Bridge Design Engr.	M:\PRELIMINARY PLANS\I-5 EVERETT HOV LANES\BRIDGE 5-633 W\t.MAN		
Supervisor	11/29/05 ADDENDUM #5		
Designed By			
Checked By			
Detailed By Nguyen, V.S. 08/04			
Bridge Projects Engr.			
Prelim. Plan By Hsieh, JC 08/04			
Architect/Specialist	DATE	REVISION	BY / APP'D

I-5 EVERETT
SR 526 TO SR 2 HOV LANES

GNRY 36TH ST OC BRIDGE NO. 5/633W WIDENING

TYPICAL SECTION
NEAR PIER 7

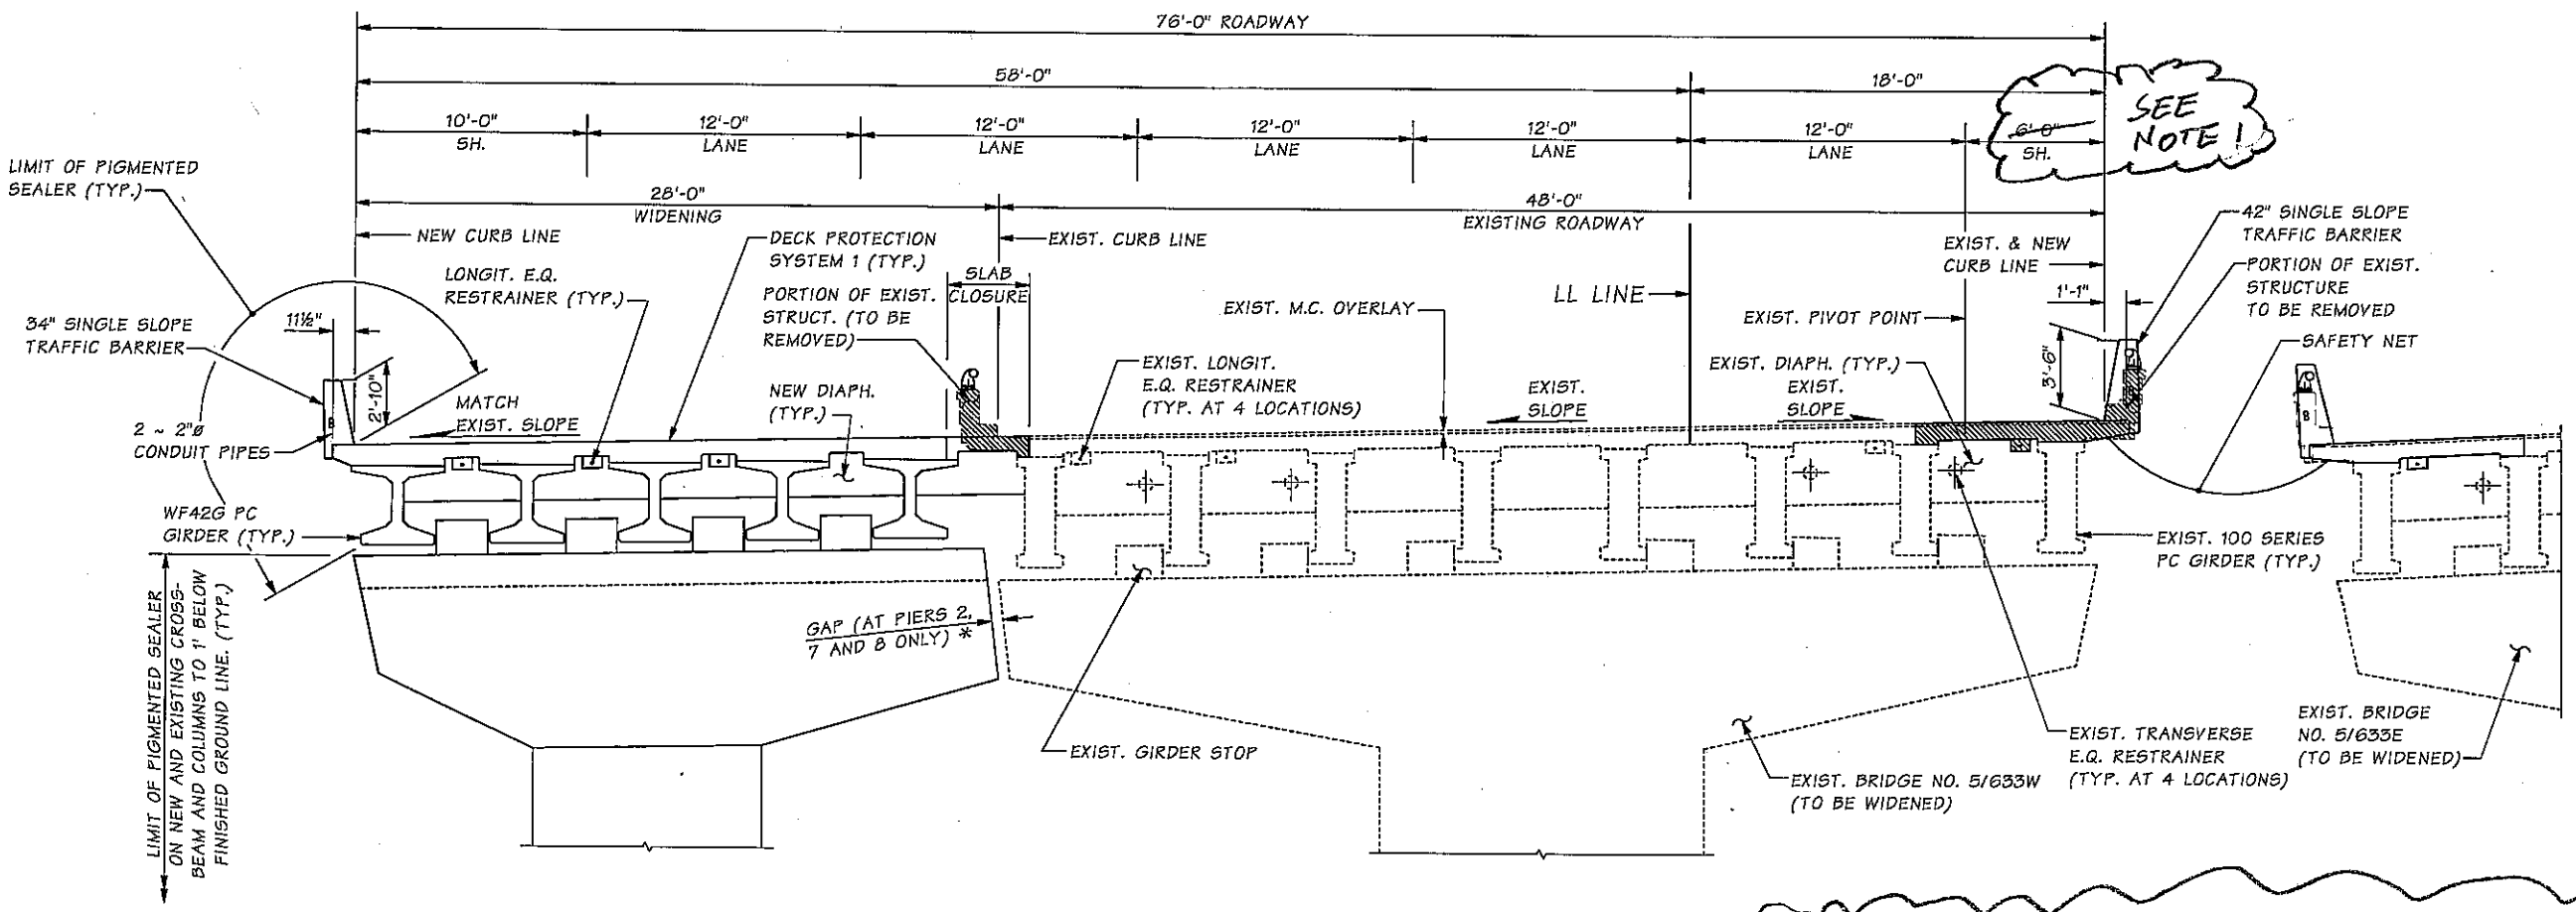
NOTE 1: WSDOT CONCEPTUAL DESIGN OF 5/633W INCORRECTLY INDICATES A 6'-0" INSIDE SHOULDER. DESIGN-BUILDER SHALL CORRECT THIS TO 8'-6" TO COMPLY WITH THE APPROVED DEVIATION IN APPENDIX M3.
